MEMORANDUM

DATE: 22 August 2023
TO: Northern Beaches Development Determination Panel
CC: Peter Robinson, Executive Manager – Development Assessments
FROM: Adam Richardson, Development Assessment Manager
SUBJECT: DA2022/1944 – 30 & 32 Lakeview Parade, Warriewood

**PROPOSED TORRENS TITLE LAND SUBDIVISION
- 2 LOTS INTO 5 LOTS**

TRAFFIC ASSESSMENT REPORT

Drawing Title: DRIVEWAY PLAN SOUTH (1:100)		Rev: A
Job No: 22-0517	Drawing No: C03

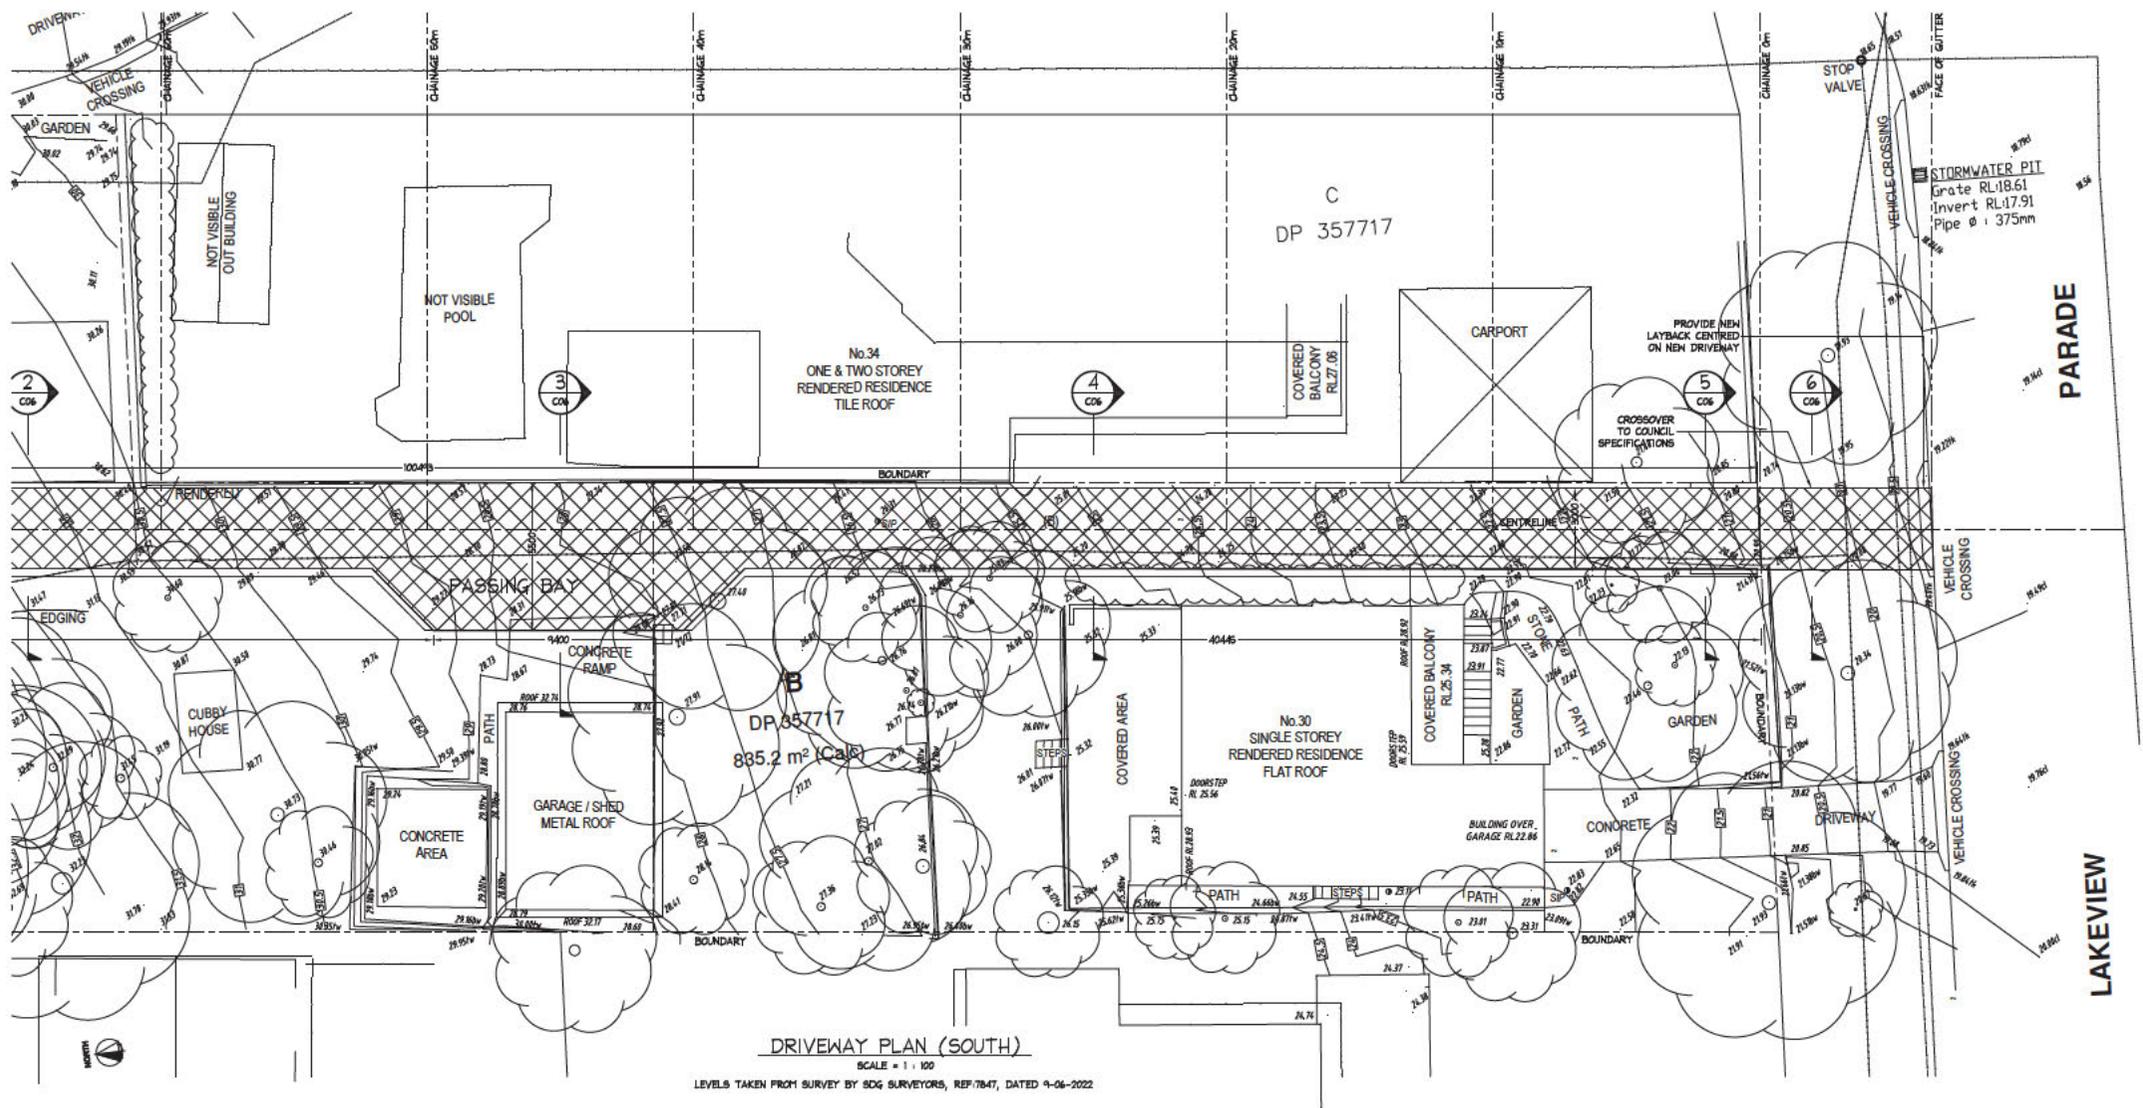
The request to provide a second passing bay at the entrance to the site was to satisfy the

As the applicant has provided a passing bay within the site and the traffic report addresses the issue related to waiting times for vehicles using the proposed development, it is considered that in order for the street tree to remain, the second passing bay, which was within the widened crossing, could be deleted in this instance. I was unaware at the time of my assessment that there was an issue related to the street tree as a result of the widening of the driveway crossing. If the tree can remain with a single 3 metre wide crossing then I can revise my comments and conditions

The request to provide a second passing bay at the entrance to the site was to satisfy the interpretation of the DCP clause B6.2 which states 'Combined driveway for more than 2 dwellings: 3.0 metres minimum except where the driveway length exceeds 40 metres, a passing bay to an overall minimum width of 5.0 metres for a length of 10 metres with suitable transitions to the adjacent narrow driveway.'

As the applicant has provided a passing bay within the site and the traffic report addresses the issue related to waiting times for vehicles using the proposed development, it is considered that in order for the street tree to remain, the second passing bay, which was within the widened crossing, could be deleted in this instance. I was unaware at the time of my assessment that there was an issue related to the street tree as a result of the widening of the driveway crossing. If the tree can remain with a single 3 metre wide crossing then I can revise my comments and conditions

3. A passing bay generally in accordance with the plan submitted by Peninsula Consulting Engineers, drawing number 22-0517 C03 Rev A dated 2/11/2022.
4. **A 3 metre wide driveway crossing.**
